Hi-Fi Products
Service Bulletin

Model: D-311

No. 366R1

Subject: LCD Display Doesn't Function Properly.

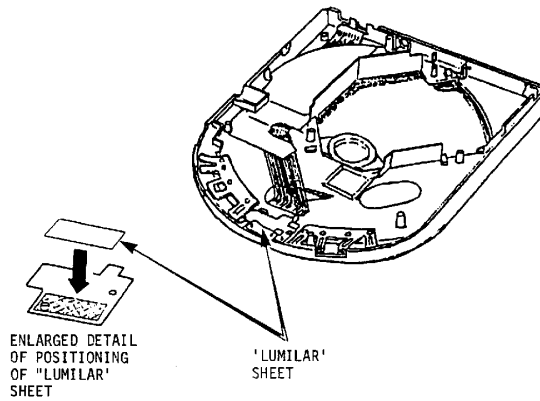
Symptom:
(13)

LCD display doesn't function properly.

1. Replace the damaged LCD flexible flat wire.
2. Stick a lumilar sheet on the point of screw that attaches the open button return spring to the upper panel.

REF	DESCRIPTION	PART NUMBER
-	LUMILAR SHEET	4-958-091-01
